## Addendum No. 04

**TO: PLANS AND SPECIFICATIONS FOR STATE OF MISSOURI**

Elevator Replacement  
Governor's Mansion  
Jefferson City, MO  
Project No: O2036-01

**SHEET TITLE:  
DEMOLITION  
FLOOR PLAN AND  
ROOF PLAN**

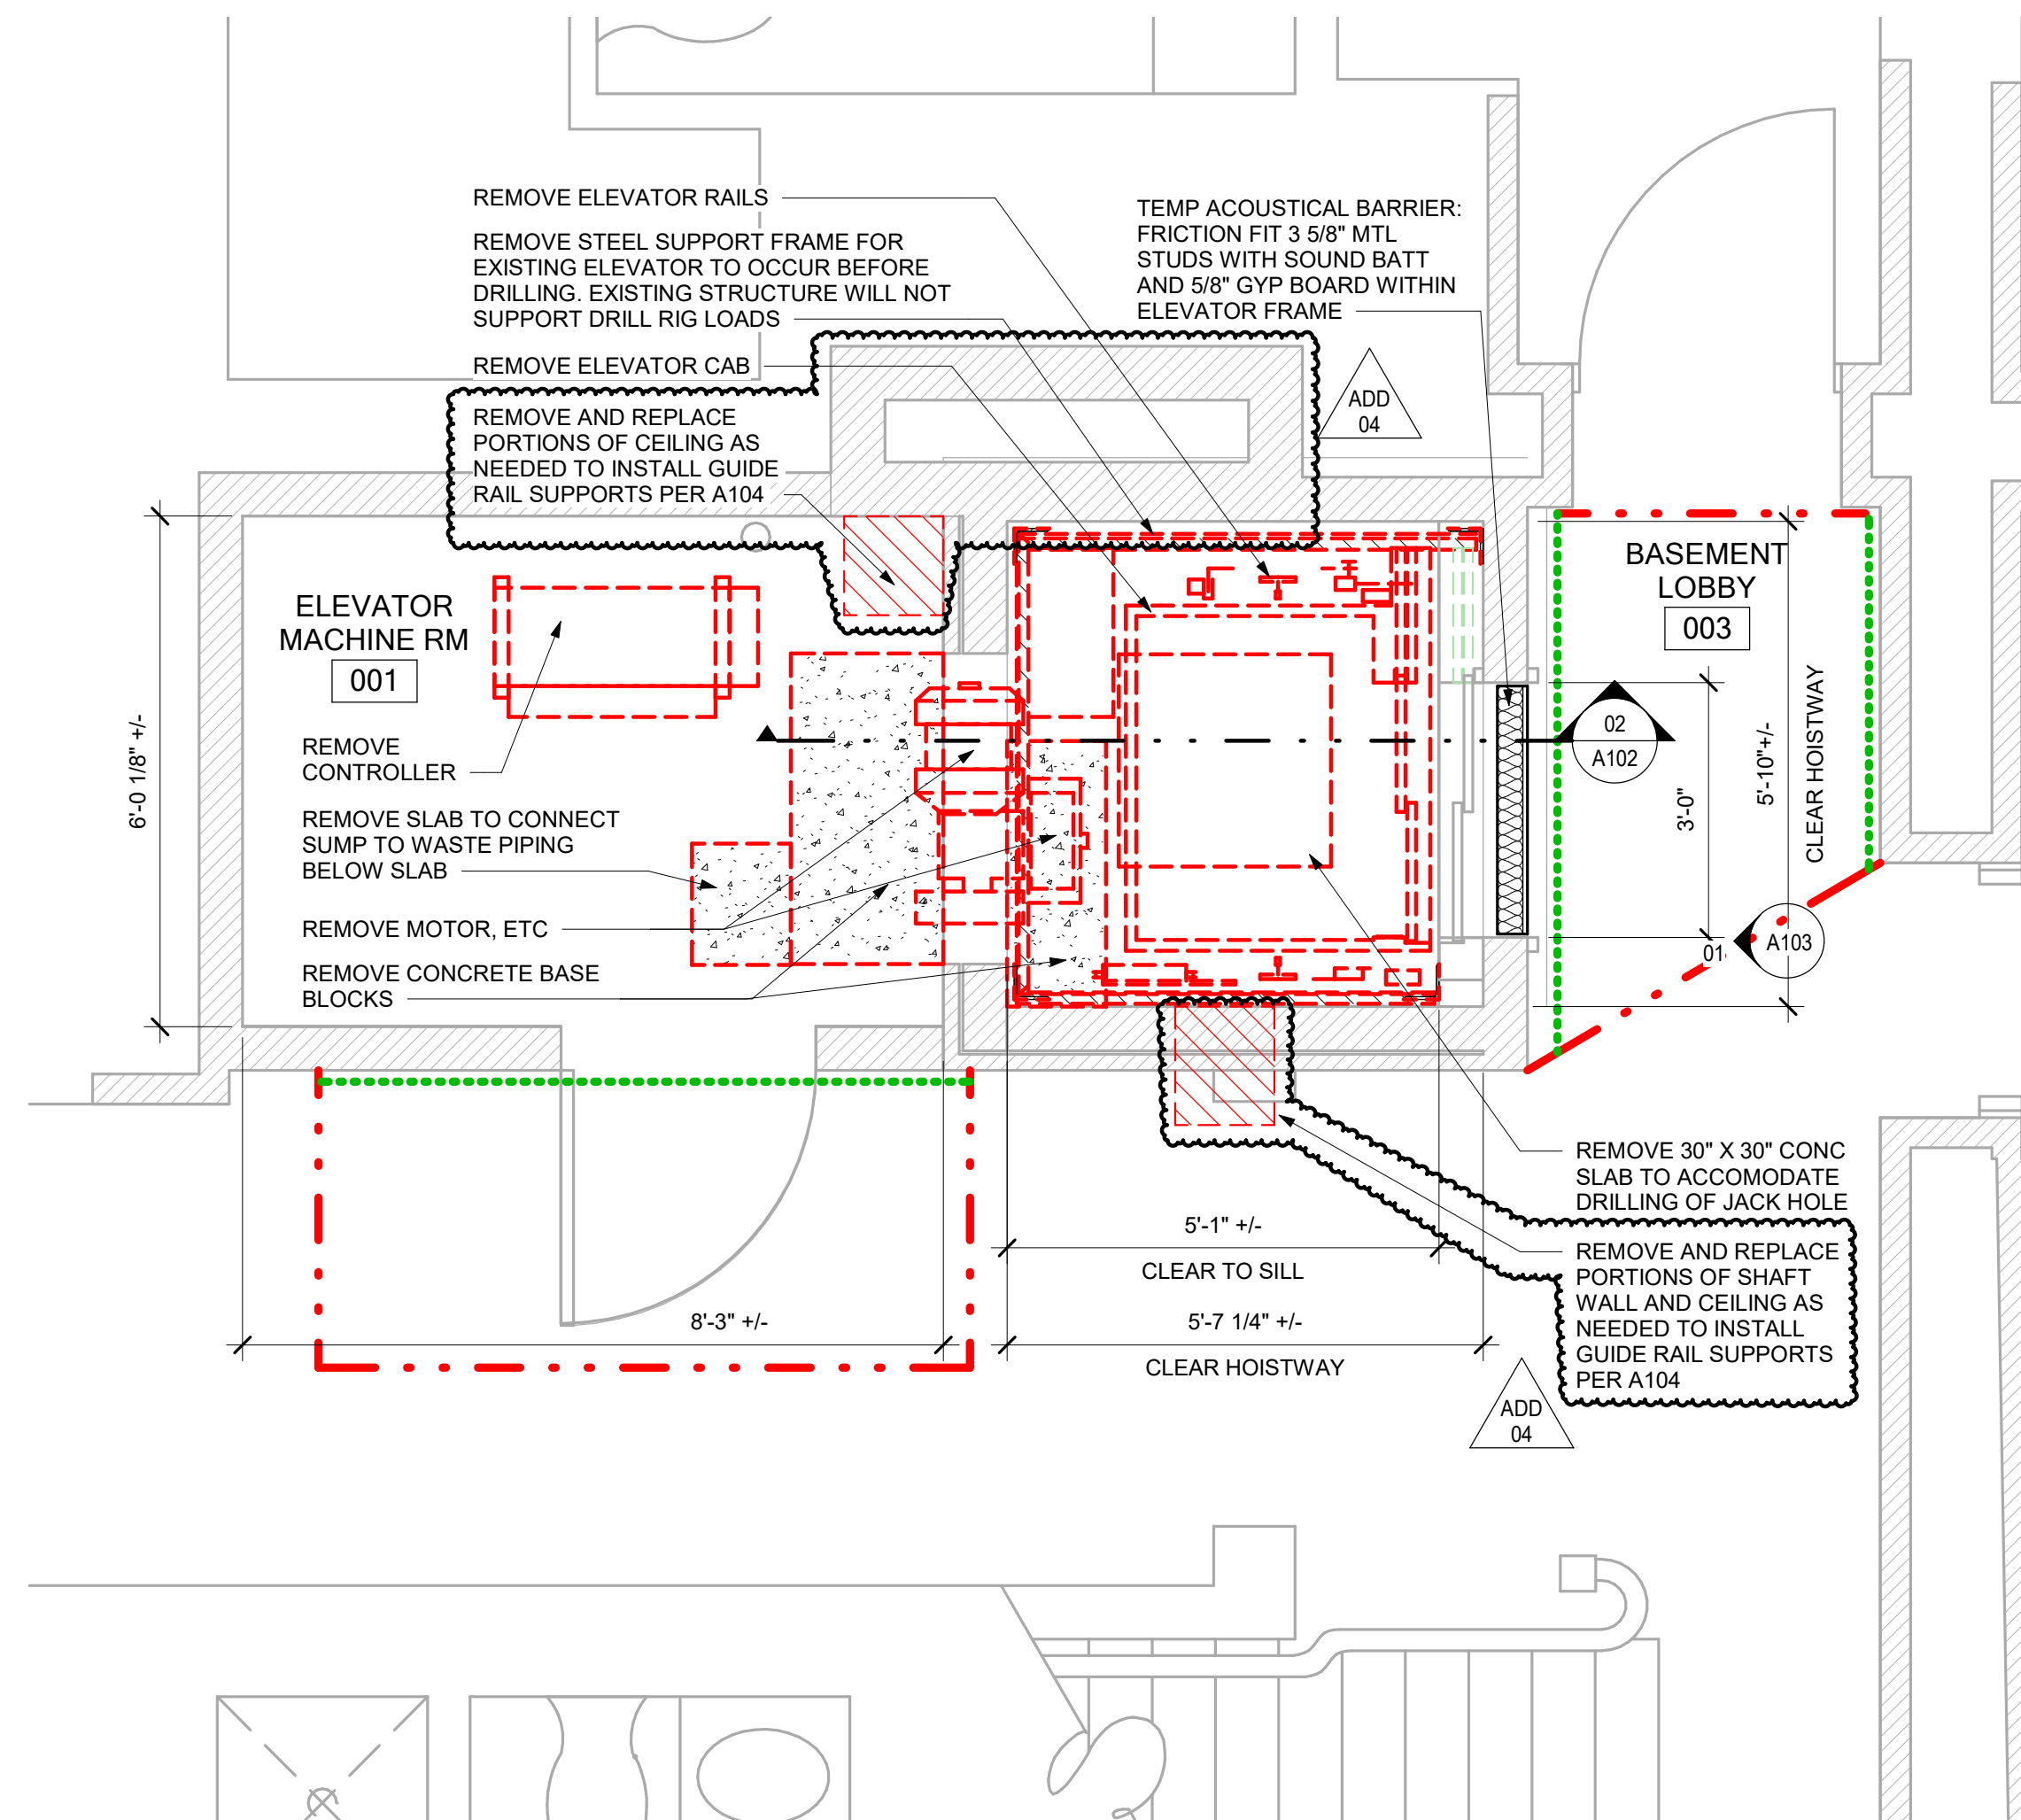
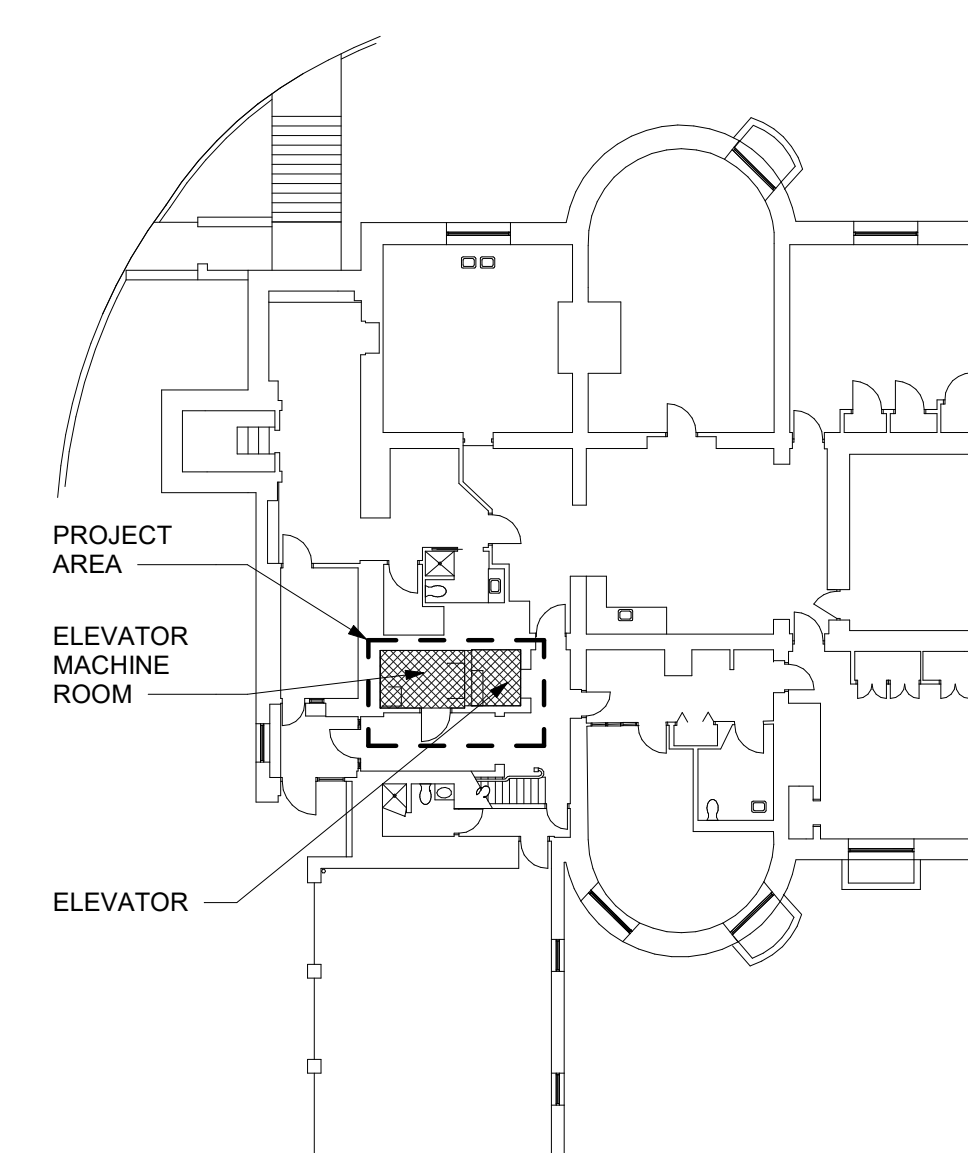
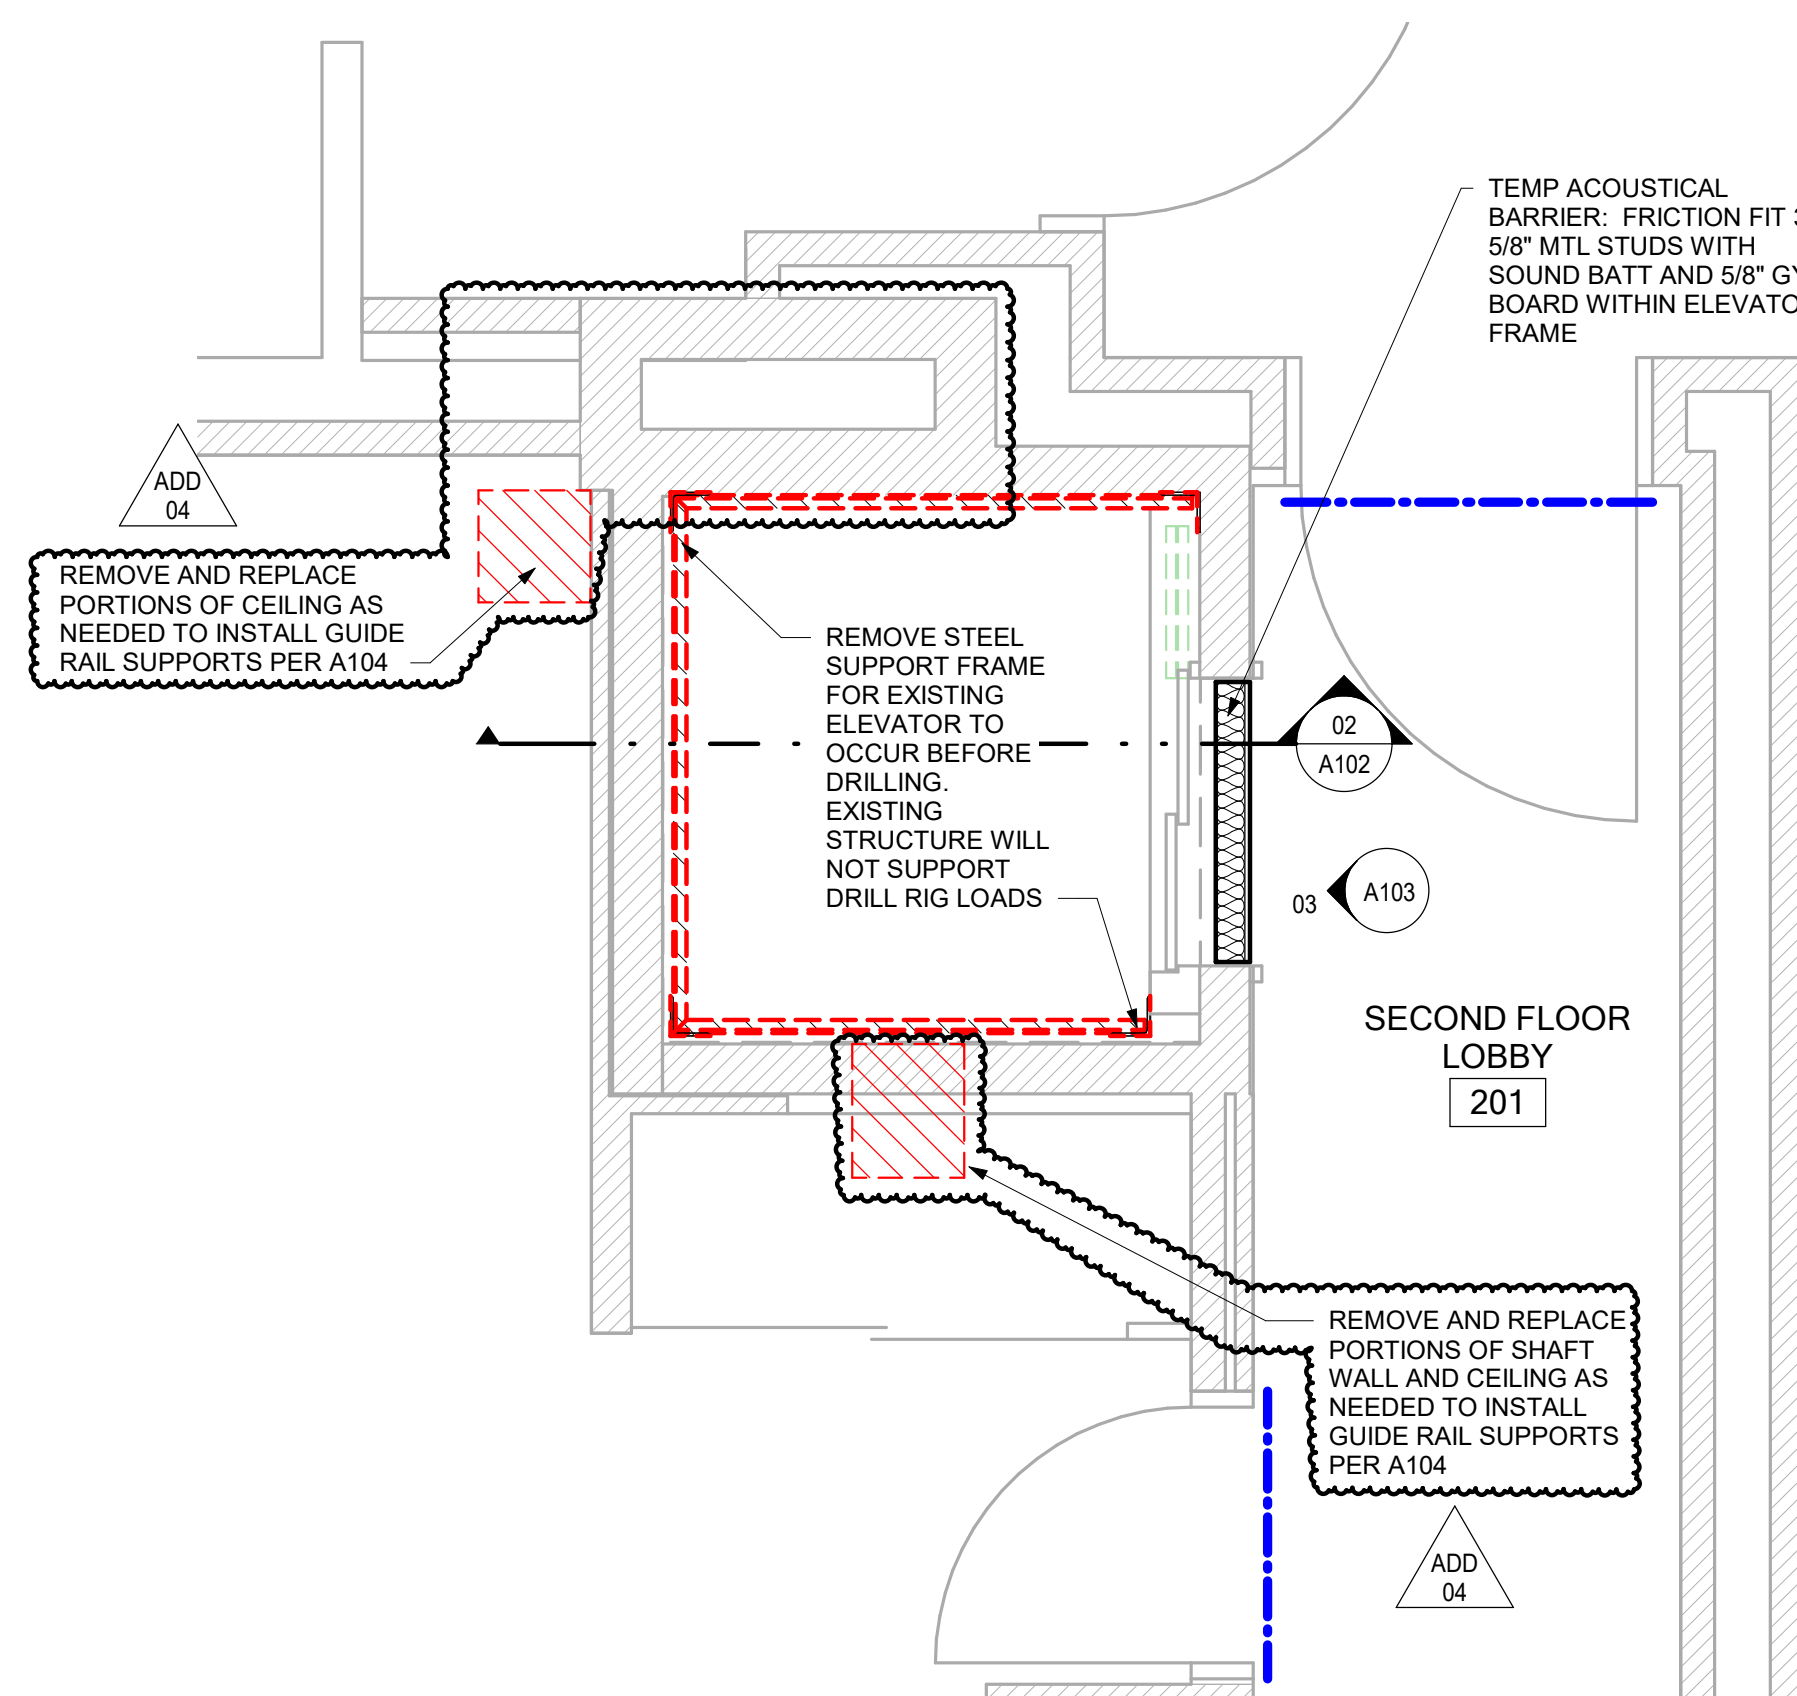
1. Drawing A101:
  - a. *Revise details 01, 02, 03, and 04 to show*
    - a. *Estimated location of existing masonry chimney.*
    - b. *Wall and ceiling demolition necessary to install guide rail bracing*
